RECEIVED
2006 SEP 18 10 49 AM '06
VEHICLE RECALL

G-06505
September, 2006

SUBJECT:NON-COMPLIANCE RECALL (U.S., EXPORT)
Davenport / Floor Joint on certain RE Buses built
between 07/01/2005 and 05/09/2006.

Figure 1

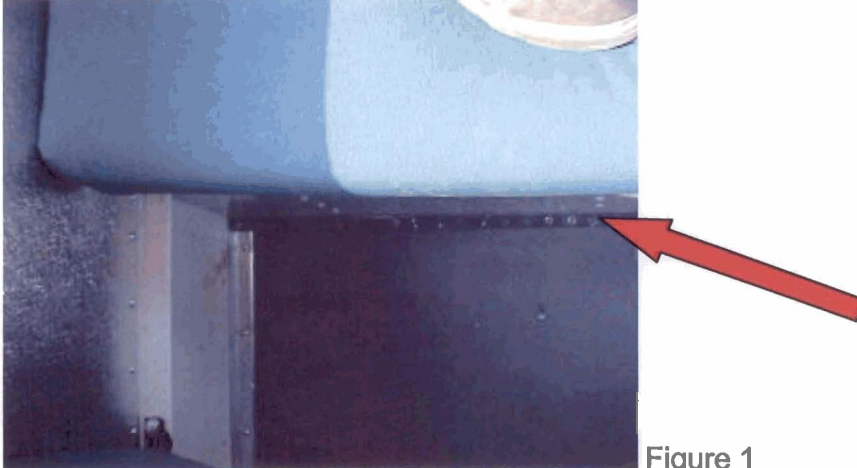
3. Remove the last screw in each piece of aisle trim (screw mounted type) so that the trim can be lifted. With screw-less trim, lift trim from retaining strip using a thin flat tool such as a large screw driver or heavy duty putty knife. The screws will need to be replaced in the screw mounted type trim at the end of the process.
4. Place a full length retaining bar (P/N 2592739C1) on the floor along the right hand side of the davenport. The bar must be placed against the outer wall and as close to the vertical face of the davenport closeout as possible. This is to ensure that the screws pass through the retaining bar and davenport closeout flange as well as the substructure under the floor. See Figure 1.

Figure 2.

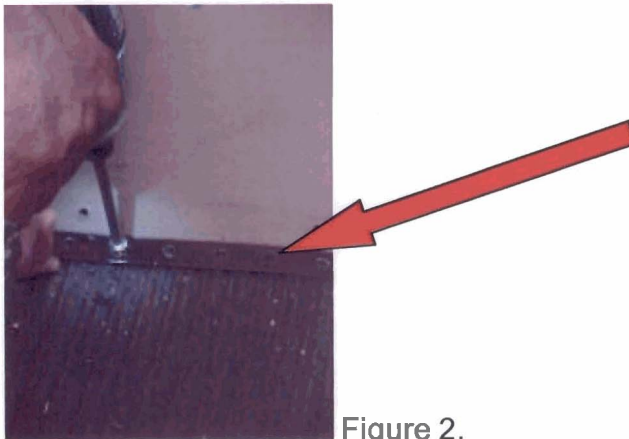
5. Before drilling any of the screw holes, place a magnetic strip or other drill guard along the vertical face of the davenport closeout to protect the painted surface from damage.
6. Using the pilot holes in the retaining bar as guides, drill through the floor material into the metal support bar under the floor with an 11/64" bit. It is recommended that a screw is installed in every 5th hole to prevent the bar from shifting or "pie crusting" (wavy affect) as the holes are drilled and screws installed.
7. Install a screw in each pilot hole location. See Figure 2.

Figure 3.

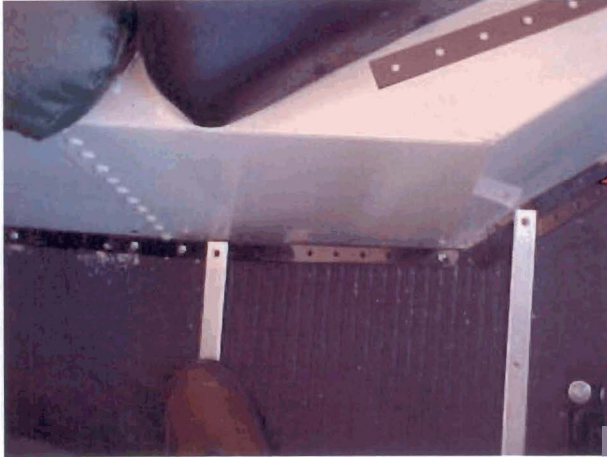
9. If the bar is too long, it is acceptable to trim the end of the retaining bar at the corner of the center davenport closeout. This may be necessary for a V-8 bus. Typically a strap cutter or bolt cutter can be used.
10. Place the remaining retaining bar adjacent to the diagonal edge of the davenport closeout. Using the length of the diagonal face of the closeout as a guide, cut a section of retaining bar to fit along the diagonal face.
11. Position the short section retaining bar as close to the vertical face of the davenport closeout as possible.

Figure 4.

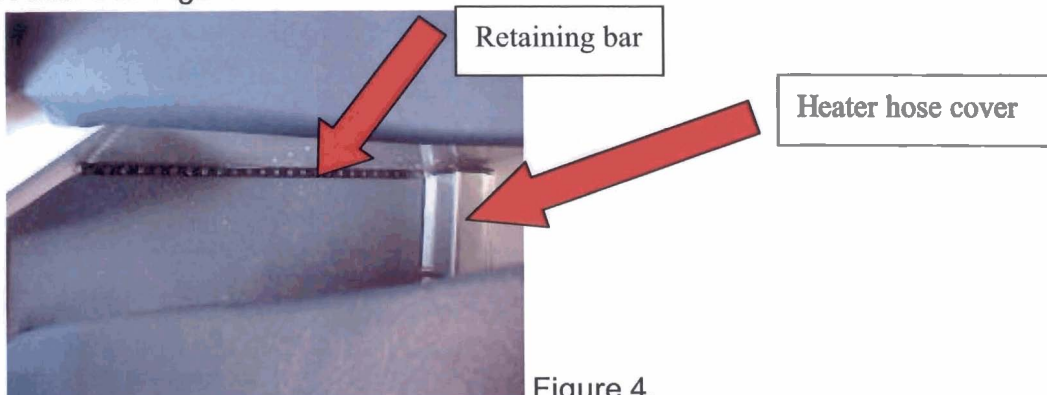
12. Drill and install screws in the pilot hole locations following the guidelines for the right hand side retaining bar.
13. Place the remaining retaining bar along the left hand side of the davenport closeout. The retaining bar on the left hand side must not be placed all the way to the side wall due to the heater hose cutout in the davenport cover. The outside end of the retaining bar must be lined up with the cutout in the davenport closeout for the heater hose. The end of the heater hose cover must be lifted to locate and mount the end of the bar. To lift heater hose cover remove screws as needed. See Figure 4.
